Subject: MHI's Responses to US-APWR DCD RAI No. 362-2278

Responses to Request for Additional Information
No. 362-2278 Revision 0

RAI NO.: NO. 362-2278 REVISION 0
SRP SECTION: 09.02.02 – REACTOR AUXILIARY COOLING WATER SYSTEM
APPLICATION SECTION: 9.2.2
DATE OF RAI ISSUE: 5/13/2009

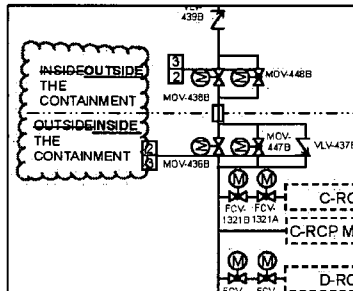
In DCD Tier 2, Figure 9.2.2-1, sheet 4 of 9, the "C" and "D" CCWS pump return needs to show the correct return headers, headers "C" and "D". The figure incorrectly shows the return headers as "A" and "B".

DCD Tier 2, Figure 9.2.2-1, sheet 4 of 9 will be revised per the attached mark up to correct the header label.

- Mark up for Figure 2.7.3.3-1 (Sheet 2 of 2):

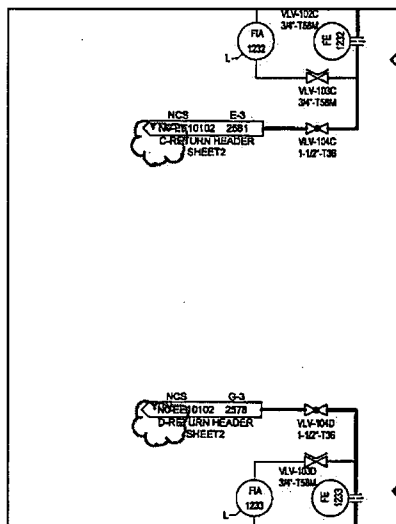
- In DCD Tier 1, Figure 2.7.3.3-1, sheet 2 of 2, the description has the equipment inside/outside containment reversed.
- In DCD Tier 1, Figure 2.7.3.3-1, safety-related support equipment is missing from the surge tank.

In DCD Tier 1, Figure 2.7.3.3-1, sheet 2 of 2, the description has the equipment inside/outside containment reversed.

DCD Tier 1 Figure 2.7.3.3-1 will be revised per that attached mark up to show the correct inside / outside containment orientation.
